TP193825 BACKSPACE MAGNET ASSEMBLY

APPARATUS AFFECTED: 28A, 28B, 28D, 28E, 28F, 28G, 28G-1, 28H, 28J, 28J-1, 28K, 28LA Perforator-Transmitter-Bases.

OBJECT: To provide more reliable operation and simplify adjusting procedure.

FIGURE 1. MANUAL AND POWER DRIVE BACKSPACE MECHANISM
FOR CHADLESS OR FULLY PERFORATED
TAPE (LATEST DESIGN)

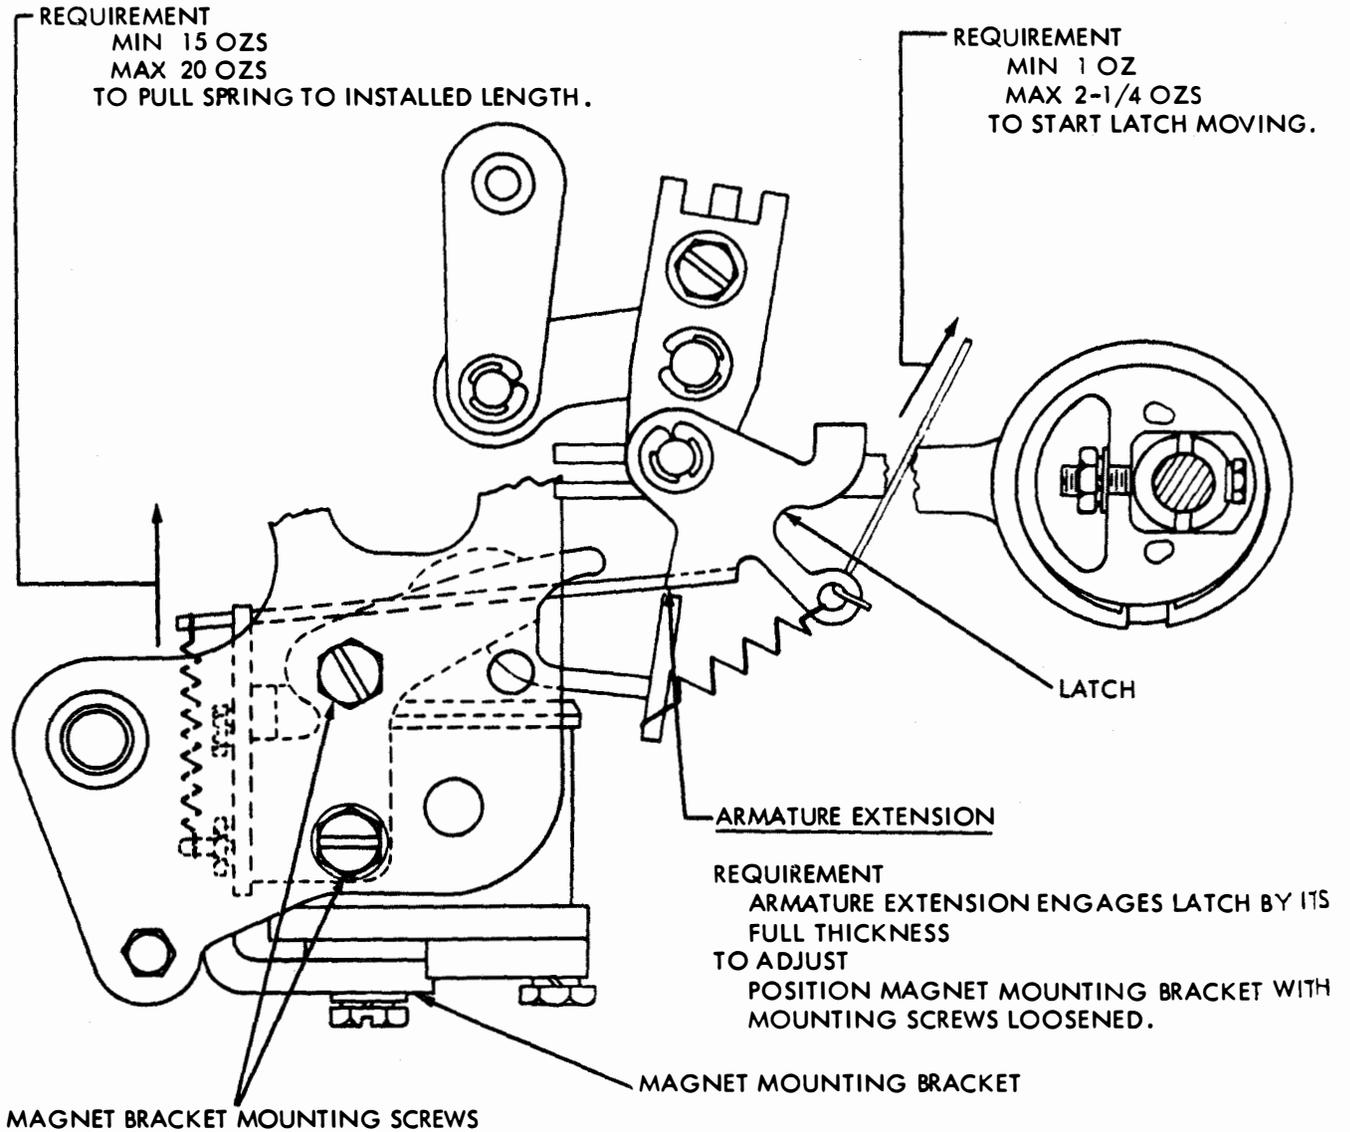
2. Requirement is added to Section 573-119-700, Section 573-118-700 and Section 573-117-700, after the last adjustment for the backspace mechanism.

See FIGURE 1.

ARMATURE SPRING

REQUIREMENT
MIN 15 OZS
MAX 20 OZS
TO PULL SPRING TO INSTALLED LENGTH.

LATCH EXTENSION SPRING

REQUIREMENT
MIN 1 OZ
MAX 2-1/4 OZS
TO START LATCH MOVING.

REQUIREMENT
ARMATURE EXTENSION ENGAGES LATCH BY ITS
FULL THICKNESS
TO ADJUST
POSITION MAGNET MOUNTING BRACKET WITH
MOUNTING SCREWS LOOSENED.
